Cotton Field (BD) Ltd. (Extension)

1st October 2023

Observations

Mismatch in structural drawings

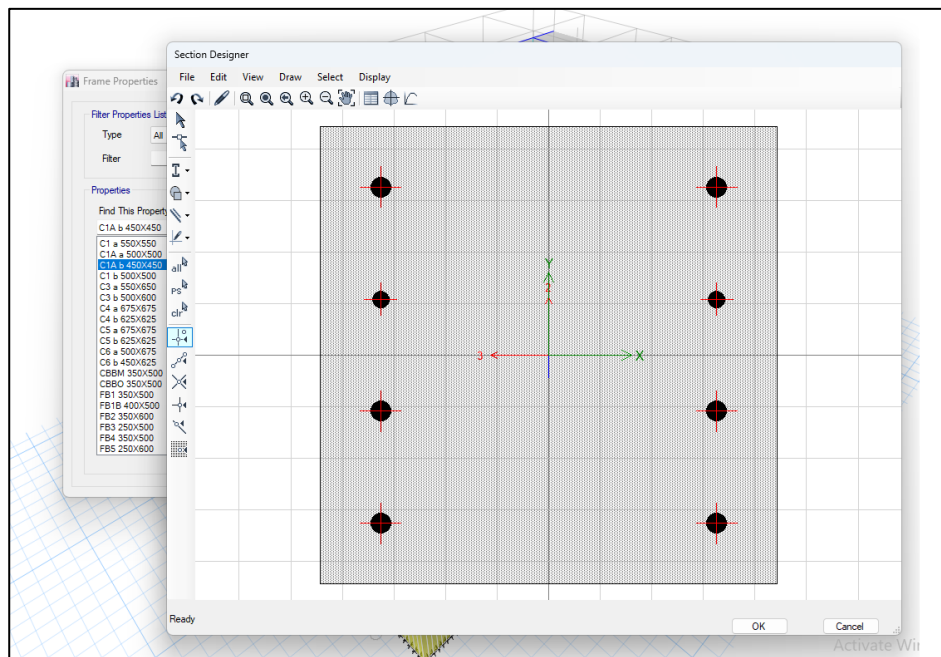
Column Schedule. 4 re-bar has been shown in a face

3-nos of re-bar was found by ferro-scanning instead of 4-nos of re-bar in a face.

Total 8 re-bar has been assigned in FEA model

The re-bar number was found mismatched for the C1A column. In as-built drawing, total re-bar of the C1A column has been shown 8-nos. But total re-bar was revealed 6-nos for the column by ferro-scanning. Also 8-nos of the re-bar has been assigned in FEA model.

The Building engineer is required to survey the whole structure and update as built structural drawing as per onsite condition and revise the design report in compliance with BNBC.

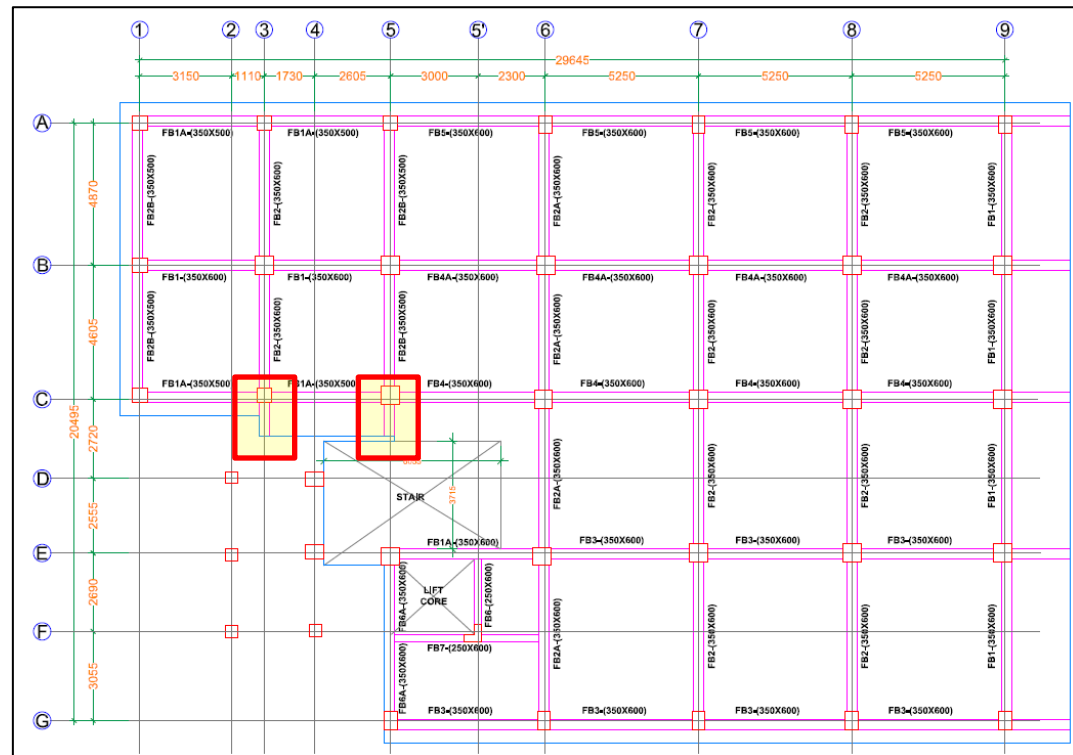
Cantilever slab. Contriver beam was not found at that position.

The marked location of beam layout plan, the cantilever beam was not found at site condition. The slab is cantilever.

The Building engineer is required to survey the whole structure and update as built structural drawing as per existing condition and revise the design report in compliance with BNBC.

Light weight stair roof shed

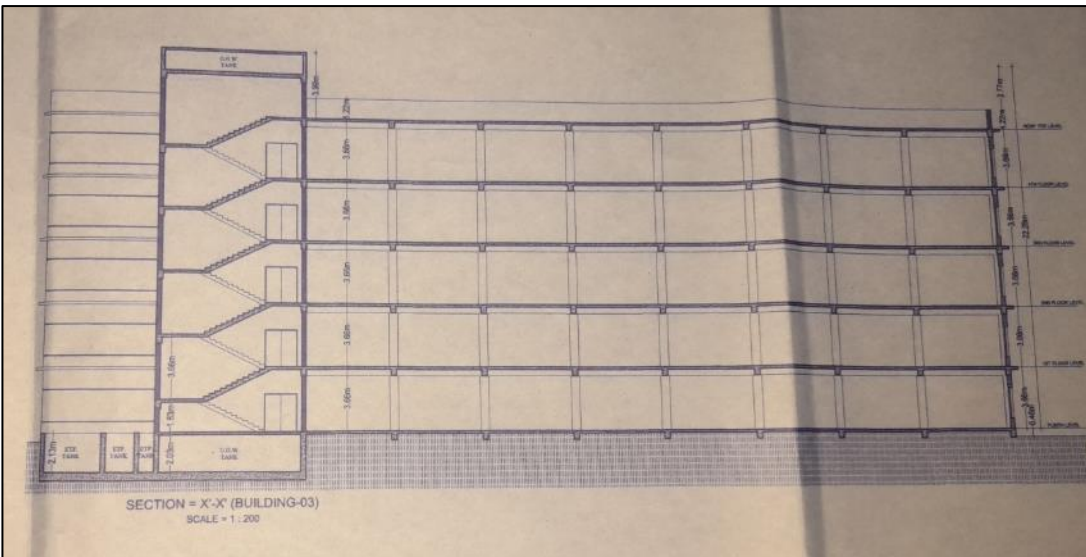
The stair roof is light-weight steel shed made of C channel & angle section is supported by brick wall. Inadequate structural member, poor connection details observed. Apparently non-engineered shed.

Building engineer is required to prepare as-built drawing and perform the adequacy check for the light-weight steel roof shed.
